UNITED STATES PATENT AND TRADEMARK OFFICE

Office Action Summary

09/993,156

Drawings

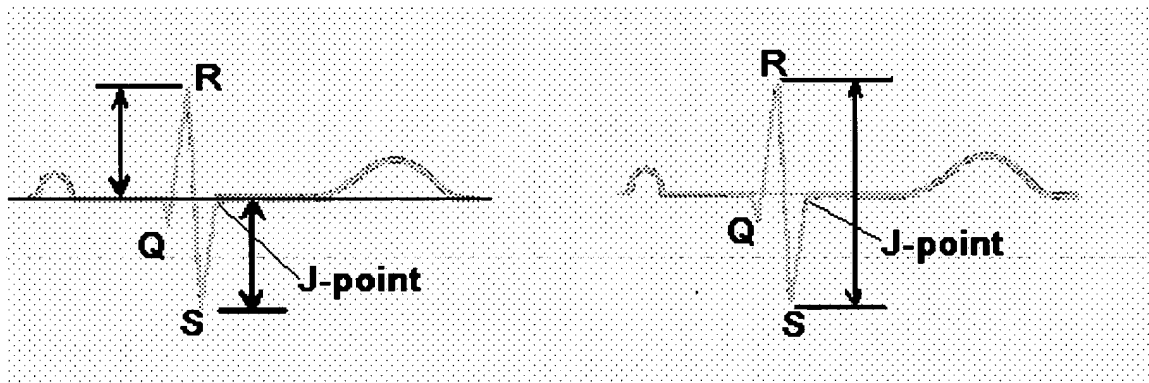
1. The drawings are objected to as failing to comply with 37 CFR 1.84(p)(5) because they do not include the following reference sign(s) mentioned in the description: Reference numerals 41-46 noted on page 7 are missing. Also the yes/no in decision block 56 and 105 is missing from Figures 5 and 10; "is separated" in block 63 of Figure 6 should be corrected. A proposed drawing correction or corrected drawings are required in reply to the Office action to avoid abandonment of the application. The objection to the drawings will not be held in abeyance.
